Consulting Arborist Services

Reference: Arborist Report Addendum –
Plan Review, Updated Tree Replacement

Site Address: 6427 East Mercer Way, Mercer Island 98040

Attachment 3: Tree Plan – Sheet A0.4 (October 28, 2025)

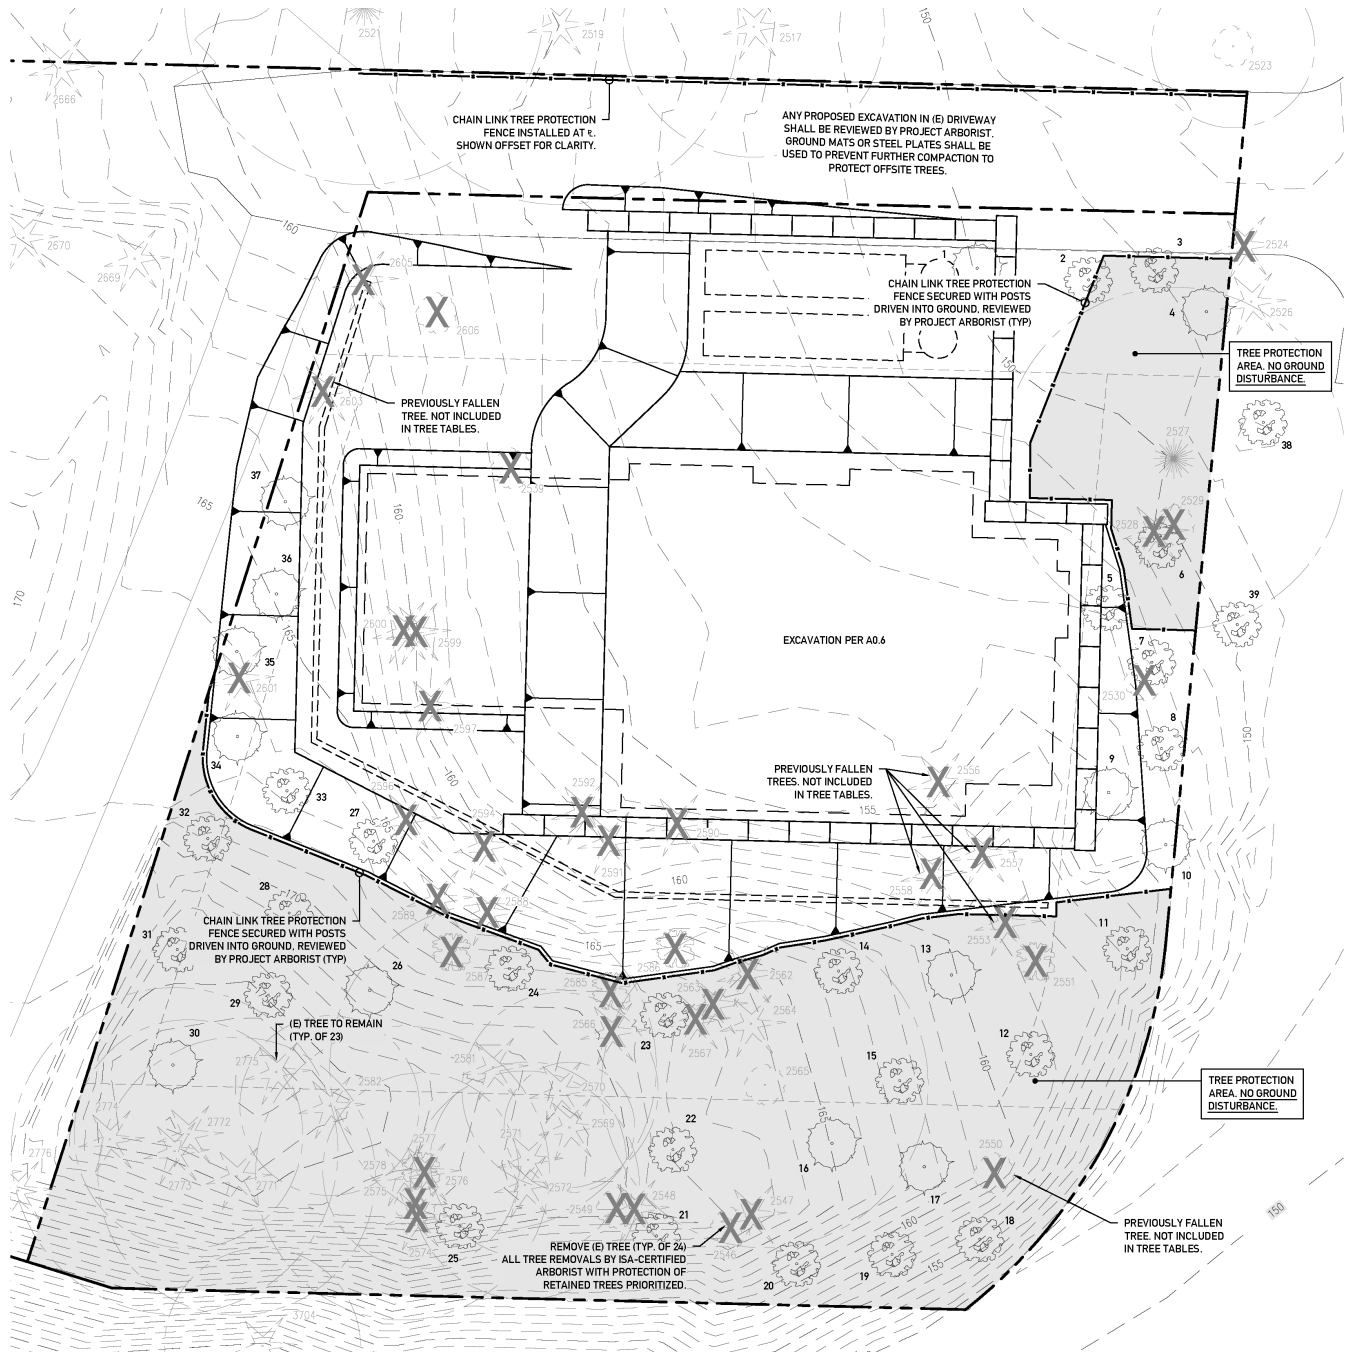
ONSITE MONITORING AND DOCUMENTATION BY PROJECT ARBORIST: ALL NECESSARY PRUNING FOR CONSTRUCTION CLEARANCE, TREE REMOVAL AS INDICATED, REVIEW OF TREE PROTECTION FENCING, TRENCHING FOR UTILITIES IN DRIVEWAY AND ROW, PAVING WITHIN DRIPLINES, LANDSCAPING WITHIN TREE PROTECTION AREA OF TREE 2527, TREE REPLACEMENT PLANTING.

Attachment 4: DRAINAGE PLAN – Sheet C.06 (November 6, 2025)

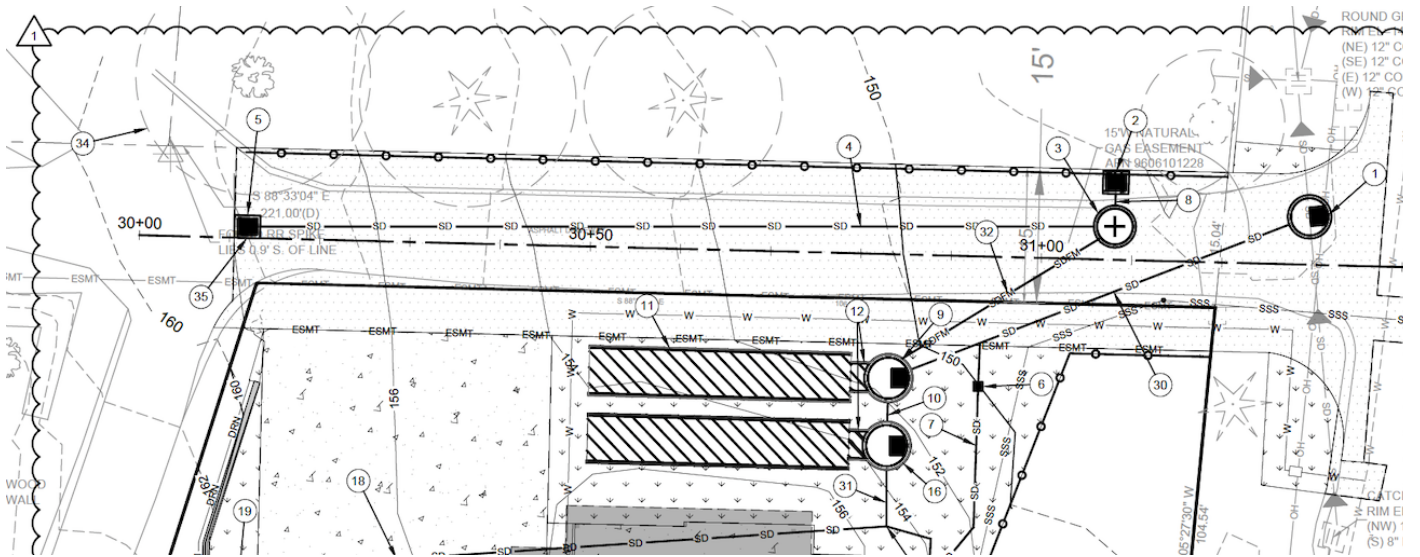
35 – ALL UTILITY TRENCHING TO BE OUTSIDE OF TREE LIMITS OF DISTURBANCE.
COORDINATION WITH PROJECT ARBORIST IS REQUIRED.
